TECHNICAL BULLETIN
Q417 UPS7014-2bNAS1
03 NOV 2014

Update Prior to Sale: Overhead Console Sunglasses Holder

Range Rover Evoque (LV)

Situation: A potential issue has been identified on a limited number of 2015 model year Range Rover Evoque (L538) vehicles where the overhead console sunglasses holder does not remain closed and/or sunglasses may rattle when stowed.

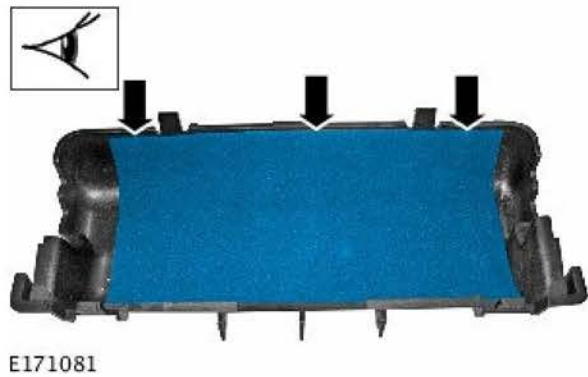
3.  **NOTE: Make sure the foam edge is aligned with rear edge of the sunglasses holder cover.**

Install the foam pad to the sunglasses holder cover.

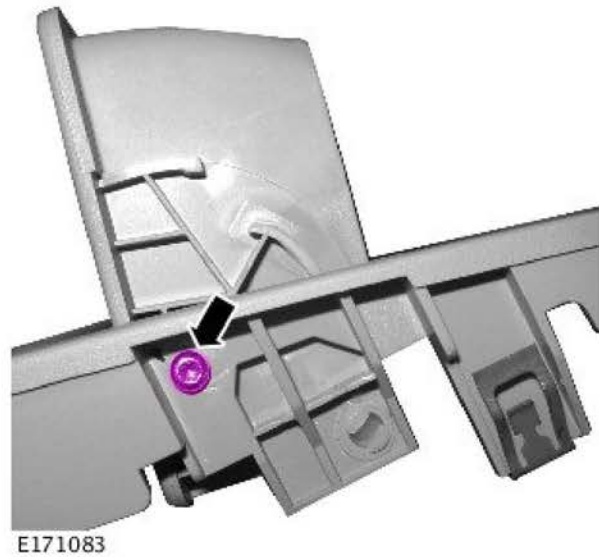
4. Install the second foam pad; to be fitted to the new sunglasses holder with the foam covering the majority of the holder.

5. Remove and discard the screw on the side of the sunglasses holder.

E171084

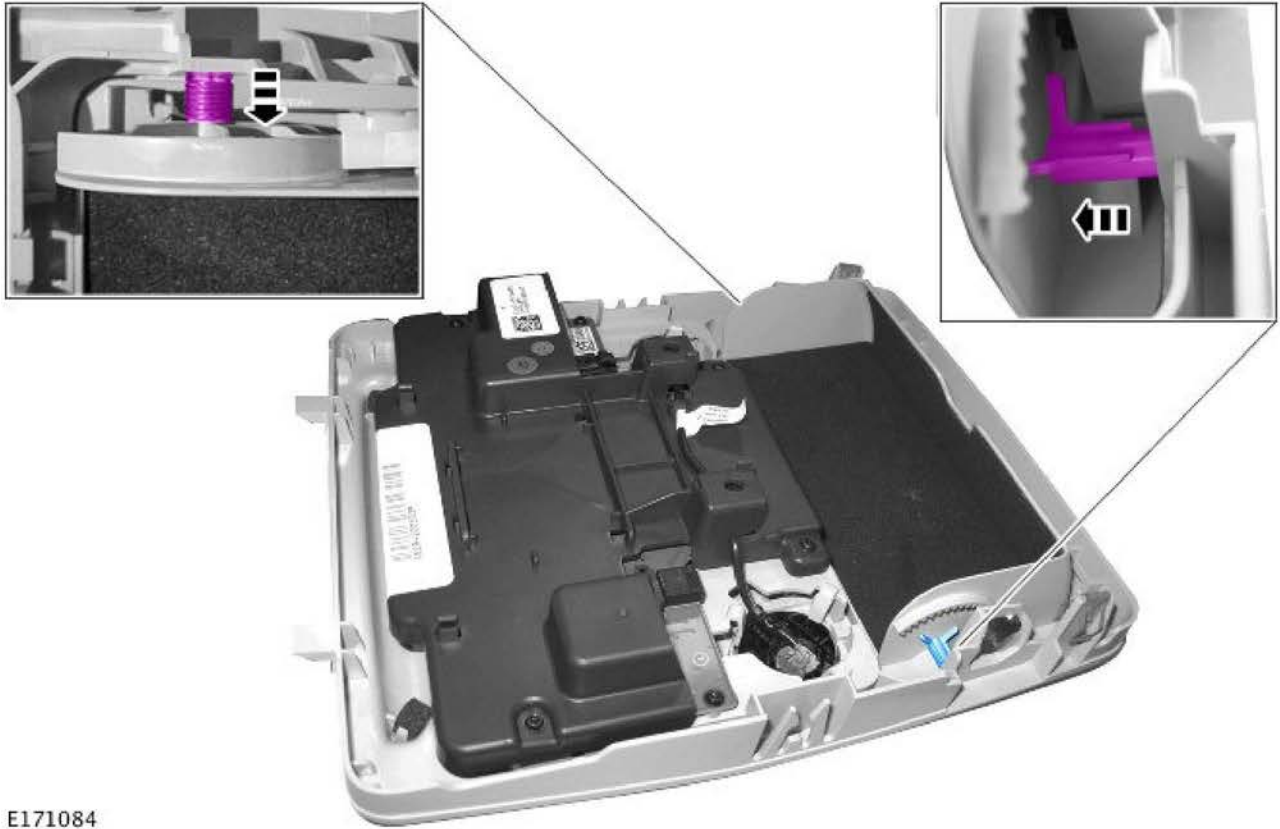
6. Remove and discard the sunglasses holder:

- Remove the pin near to the damper;
- Remove the pin on the other side of sunglasses holder door;
- Discard the sunglasses holder.

E171086

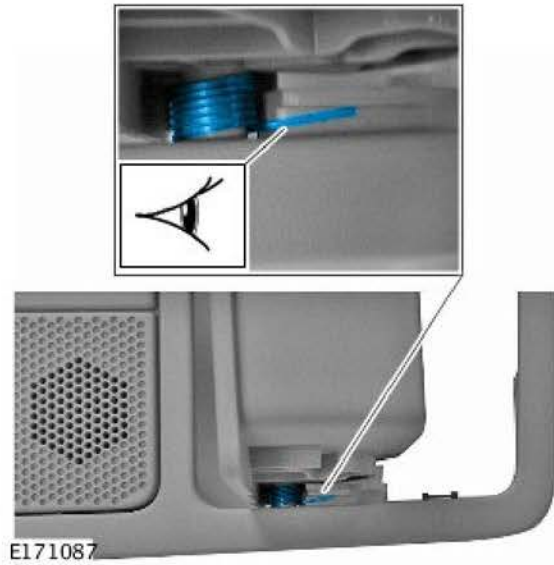
- 7.  **NOTE: Nyogel 774L (from the Squeaks & Rattles Kit; refer to Technical Bulletin LTB00389NAS).**

Using Nyogel 774L or equivalent, apply into the hinge pin holes.
